Access Compliance Report

Public Rights-of-Way

Intersection ID: N/A	Main Street: PINEVILLE-MATTHEWS_RD	Cross Street: N/A	Location: N
ADA ID: 89A8B66A8BD3	Ramp Type: PerpDiag	Initial Pass/Fail: Fail	Overall Compliance: No
			Severity Score: 13.75

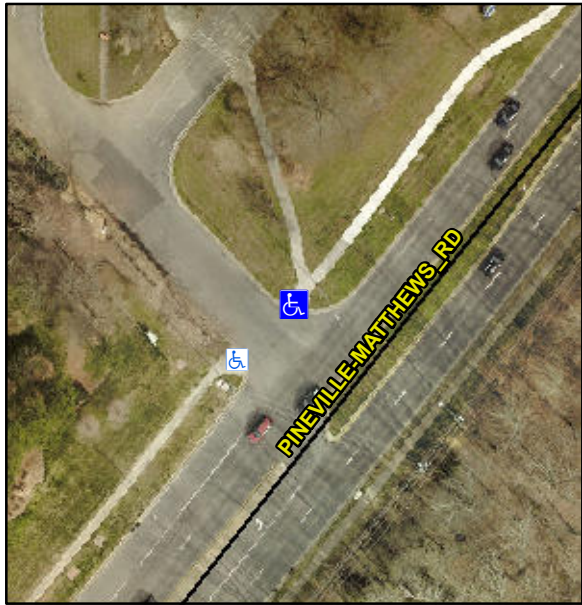
Codes/Mitigation Info/Possible Solution			Field Measurements/Component Compliance					
	Possible Solutions:		Compliance	Description	Data	Compliance	Description	Data
	Remove & Replace Curb Ramp With Two New Directional Ramps or Equivalent.		N/A	Ramp Length (in)	154.0	No	Ramp Slope (%)	10.7
			Yes	Ramp Width (in)	48.0	No	Ramp XSlope (%)	2.9
			N/A	Flare Type LT	N/A	N/A	Flare Type RT	N/A
			N/A	Flare Slope LT (%)	N/A	N/A	Flare Slope RT (%)	N/A
			N/A	Flare Traversable LT?	N/A	N/A	Flare Traversable RT?	N/A
			N/A	Landing Length (in)	N/A	N/A	DWS Provided?	N/A
			N/A	Landing Width (in)	N/A	N/A	DWS Contrast?	N/A
			N/A	Landing Slope (%)	N/A	N/A	DWS Length (in)	N/A
			N/A	Landing X Slope (%)	N/A	N/A	DWS Full Width?	N/A
Surveyor Notes:	N/A		N/A	Landing Curb? (Y/N)	N/A	N/A	DWS Offset (in)	N/A
			N/A	Shared Landing?	N/A			
	PROW/ADA:		N/A	Gutter Ponding?	N/A	N/A	Gutter Slope (%)	N/A
	Not Found, R304.2.2, R304.5.3		N/A	Gutter Lip Ht (in)	N/A	N/A	Gutter X Slope (%)	N/A

N/A	Painted X Walk1?	No	N/A	Painted X Walk2?	No
				X Walk 1 Direction	To SW		X Walk 2 Direction	To SE
			N/A	X Walk 1 Width (in)	N/A	N/A	X Walk 2 Width (in)	N/A
				X Walk 1 Slope (%)	0.7		X Walk 2 Slope (%)	3.9
				X Walk 1 X Slope (%)	3.2		X Walk 2 X Slope (%)	0.4
			N/A	Ramp inside XWalk1?	N/A	N/A	Ramp inside XWalk2?	N/A
			Road Slope (%)	3.6	N/A	Clear Space?	N/A	
			Road X Slope (%)	1.0	N/A	Clear Space to XWalk (in)	N/A	
		N/A	Any Obstructions?	N/A	N/A	Storm Grate/Utility Hazard?	N/A	
			Obstruction Type			Storm Grate/Utility Type		
				N/A			N/A	
					Yes	Surface Condition? (G/P)	Good
